## ACURA ServiceNews Article

B17070B Version 1

## Where's the Sealing Bolt in That Reman 9-Speed A/T?

2016-17 MDX and 2015-17 TLX

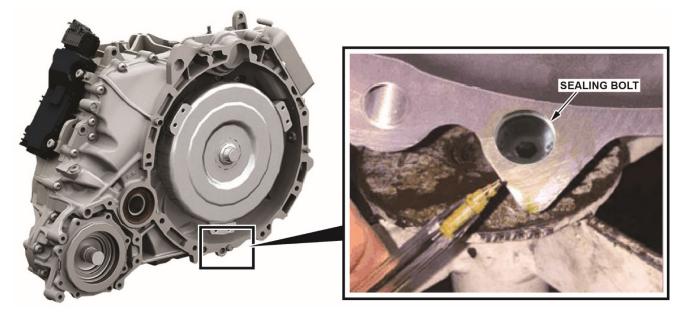
Because of a transmission case casting flaw, the inside of the torque converter bracket bolt hole in some 9-speed A/Ts is porous enough that ATF could leak from the hole. This flaw was found by the transmission factory during production.

As a temporary fix, the factory installed a sealing bolt in that hole and it's proven effective. That casting issue has since been resolved. Later castings don't have that issue, so there's no need for the sealing bolt.

If you order a reman A/T and its serial number is **higher** than what's listed in this chart, don't worry about a missing sealing bolt. That A/T has a case that doesn't need it, so it doesn't come with one.
